UNION CARBIDE CORPORATION

CORPORATE RESEARCH LABORATORY

Subj: PROPOSED AMENDMENT TO SPECIAL NUCLEAR MATERIAL (SNM) LICENSE No. 639.

FIGURE 1

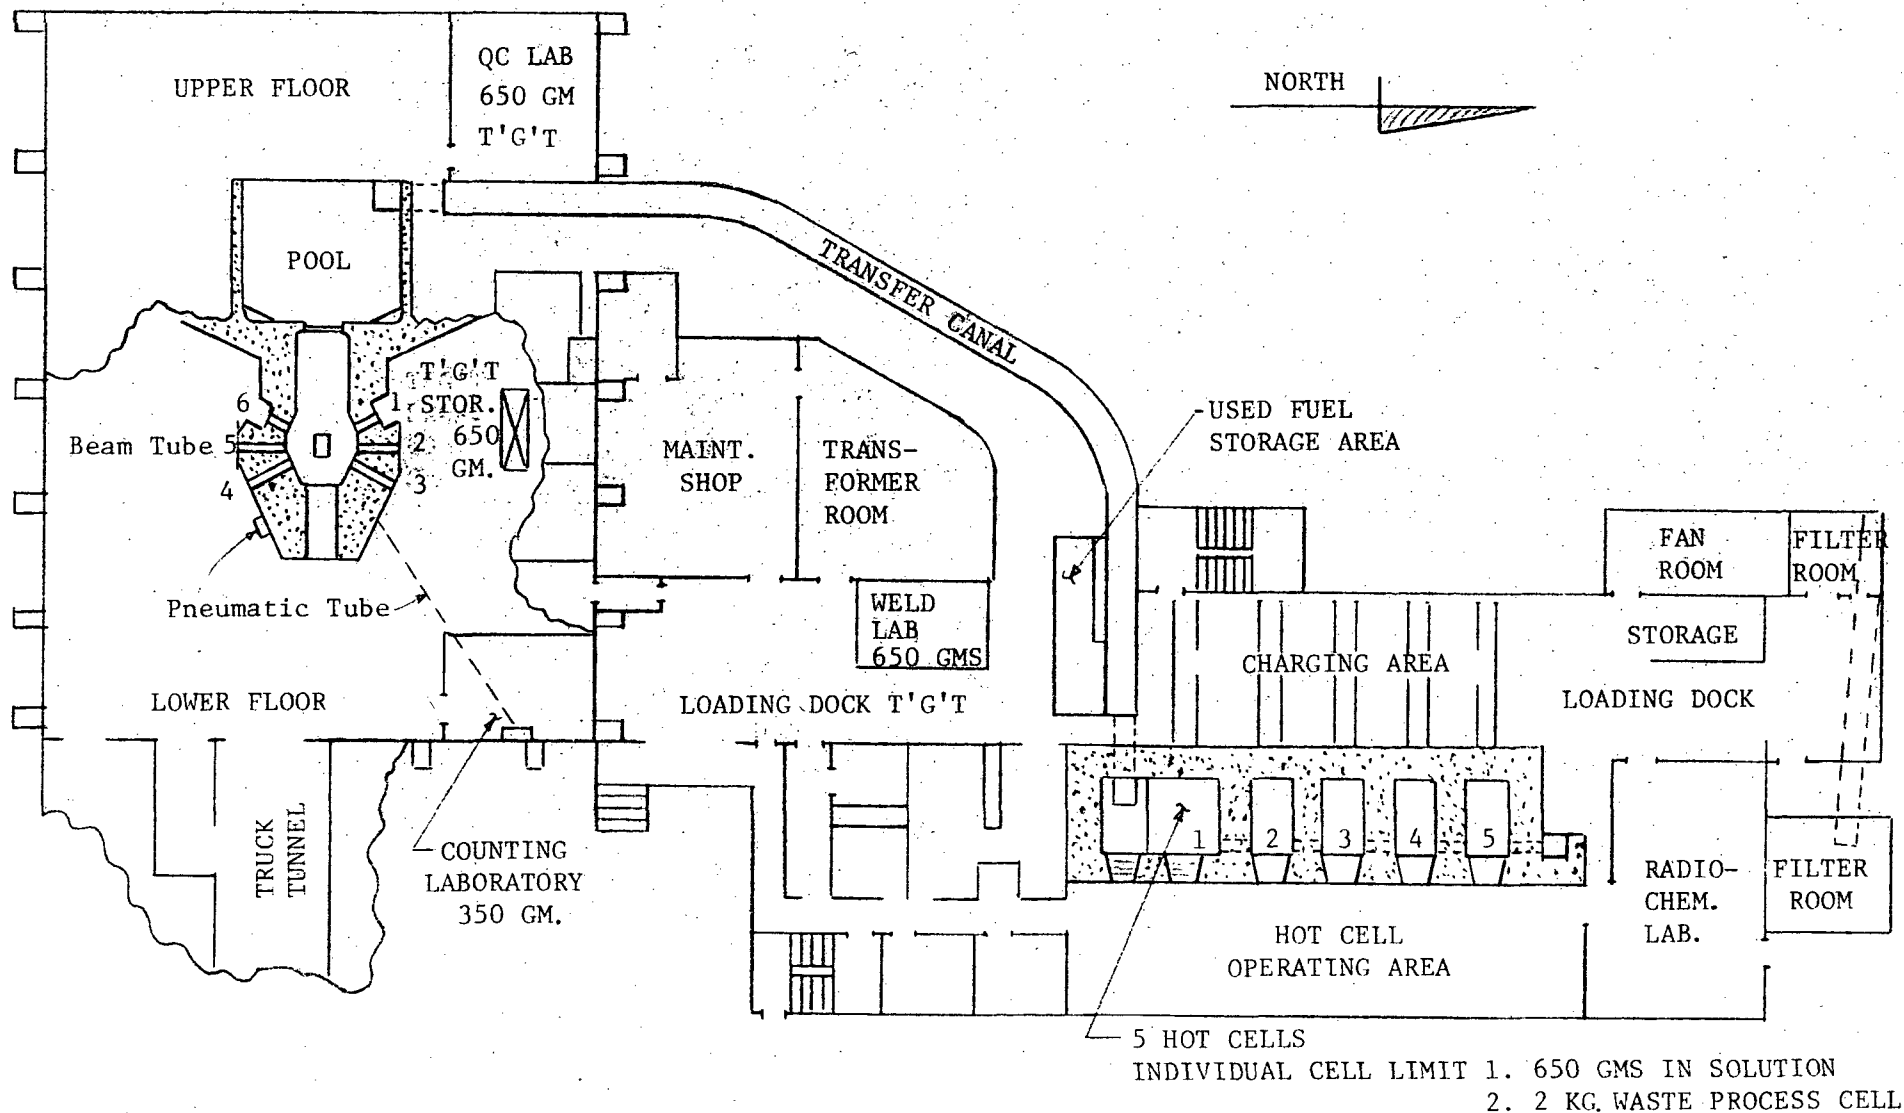
Revised floor plans are included to reflect the current storage locations and processing laboratories. A check in the amount of \$150.00 is enclosed to cover the administrative fee requirements of 10 CFR 170.31.

FIGURE 1A

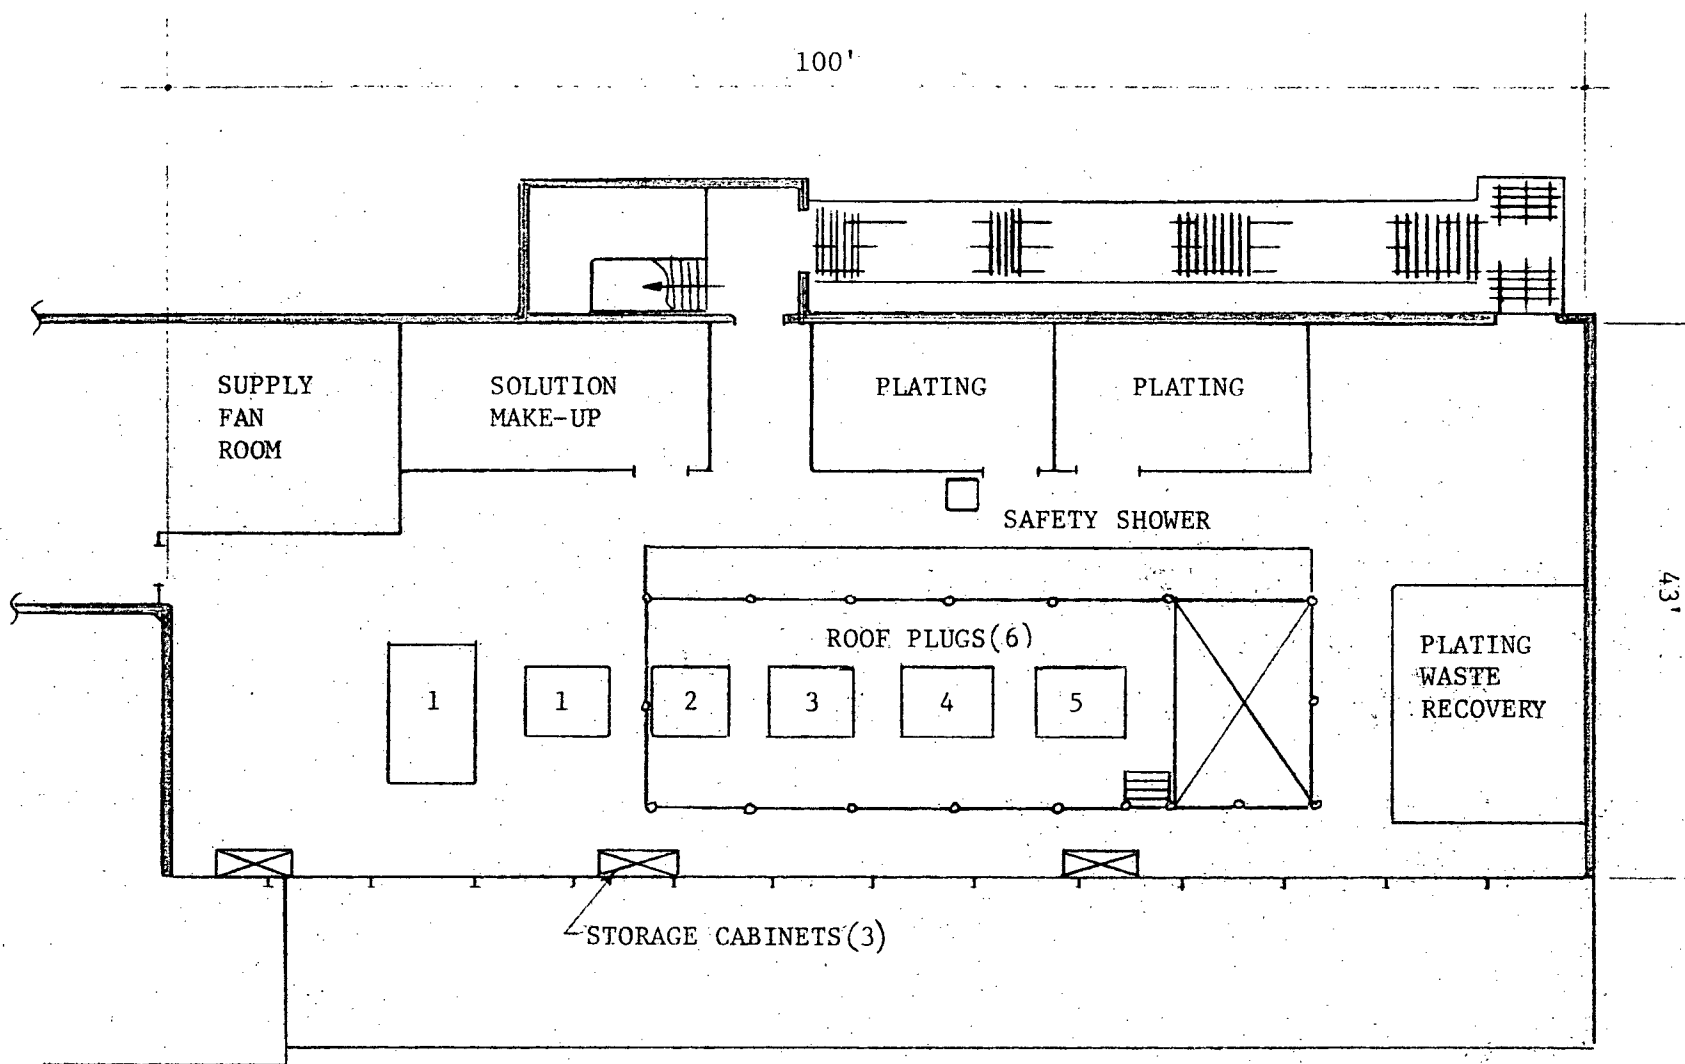
Uranium is stored in storage cabinets in the upper level of the hot laboratory (Fig. 1A). Material in liquid form is doubly contained. Storage cabinets are of fireproof construction, are separated by a minimum distance of three feet and are fastened to prevent inadvertent movement. All cabinets are locked and keys are in the custody of the SNM custodian for the area. Criticality control is implemented by limiting the quantity of SNM in solution to 350 grams per storage cabinet. This limit allows a safe margin below the single parameter limit of 760 grams U-235 in uniform aqueous solutions specified in the ANSI N16.1-1969 standard even

- "A.3. Unirradiated SNM in solution shall not exceed 350 grams in a single laboratory."
- "A.4. SNM, as an oxide, encapsulated for irradiation shall not exceed 650 grams in a single laboratory. When SNM is in process in the plating lab (Fig. 1A), it can be either as a solid (oxide) or in solution (electrolyte 15 gms/liter, H:U ~ 1500) and the quantity of either form shall be governed by the formula:

"A.2. All unirradiated SNM when not in use, shall be kept in locked steel cabinets which are located within a restricted area of the hot laboratory. The amount of U-235 in a single cabinet shall be limited to 350 grams in solution or 650 grams as  $UO_2$  or  $U_3O_8$ . The spacing between SNM storage cabinets shall be a minimum of three feet and each cabinet shall be fastened to prevent inadvertent movement. SNM in liquid form shall be doubly contained."
